# UNITED STATES PATENT AND TRADEMARK OFFICE

APPLICATION NO.	FILING DATE	FIRST NAMED INVENTOR	ATTORNEY DOCKET NO.	CONFIRMATION NO.
10/542,646	07/19/2005	Johannes Fridolin Schlapfer	8932-1208-999	1676
51832	7590	09/01/2006	EXAMINER	
JONES DAY 222 EAST 41ST STREET NEW YORK, NY 10017-6702				CUMBERLEDGE, JERRY L
		ART UNIT		PAPER NUMBER
		3733

<b>Office Action Summary</b>	<b>Application No.</b>	<b>Applicant(s)</b>
	10/542,646	SCHLAPFER ET AL.
	<b>Examiner</b>	<b>Art Unit</b>
	Jerry Cumberledge	3733

## **DETAILED ACTION**

**Fig. 3**

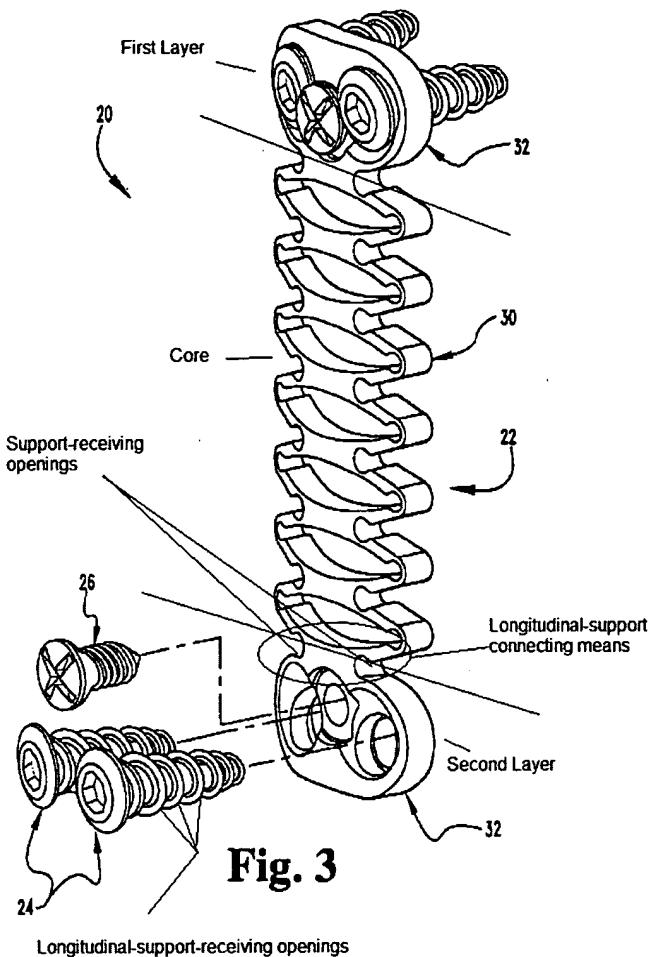
The longitudinal support is constructed in the shape of a flat band or strip (Fig. 3, ref. 22). The longitudinal support is constructed so as to be rotationally symmetrical (paragraph 0031, lines 6-10). The longitudinal support comprises an in particular plastically deformable core (paragraph 0036, lines 1-5) (Fig. 4a, ref. 30) made of metal (paragraph 0035, lines 1-5) in particular titanium or a titanium alloy (paragraph 0035, line 4), which is encased in a human-tissue-compatible plastic (paragraph 0035, line 5 and paragraph 0032, lines 20-24), in particular one that ensures flexibility within a stable shape state (paragraph 0055, lines 10-15). The longitudinal support is so dimensioned that within the elastic flexion range its surface stress is always below the dynamic breaking stress. In the case of a longitudinal support core, both the core and the casing are dimensioned such that in the elastic flexion range the surface stress of both core and casing is always below the respective dynamic breaking stress. The elastic flexion range for any material is always less than the stress required to fracture or break the material and therefore the apparatus of Justis et al. has this property also.

The core is encased in more than one layer (Fig. 3 below). The apparatus comprises bone-anchoring means, in particular pedicle screws (Fig. 2, ref. 24), to which the longitudinal support or supports can be fixed. The apparatus comprises longitudinal support connecting means (Fig. 3 below), which can be used to connect at least two support sections to one another. The longitudinal-support-connecting means comprise two oppositely situated support-receiving openings (Fig. 3 below), into each of which an

end section of the support can be inserted and fixed by way of a clamping screw or similar clamping element. The bone-anchoring means comprise longitudinal-support-receiving openings (Fig. 4a, ref. 54) that can be spaced at variable axial distances from the opposite distal end, so that the longitudinal support can be adjusted to a correspondingly different distance from the vertebra (Fig. 4a, and Fig. 4b). The core is constructed in the form of a flat band or strip (Fig. 11a, ref 32), with a width smaller than or equal to the corresponding dimension of the longitudinal support (Fig. 4b). The core is rotationally symmetrical (Fig. 12 and Fig. 13, ref 302), in particular circular (Fig. 12 and Fig. 13, ref 302), with either a constant diameter (Fig. 13, ref 302) or a diameter that varies along the length of the longitudinal support. The diameter of the core, at least in sections, is continually enlarged or reduced and/or altered in a stepwise manner (paragraph 0037, lines 1-15) such that in the last case the transitions in the region of a step are constructed so as to reduce stress, in particular are rounded (paragraph 0037, lines 12-15).

Longitudinal-support-receiving openings
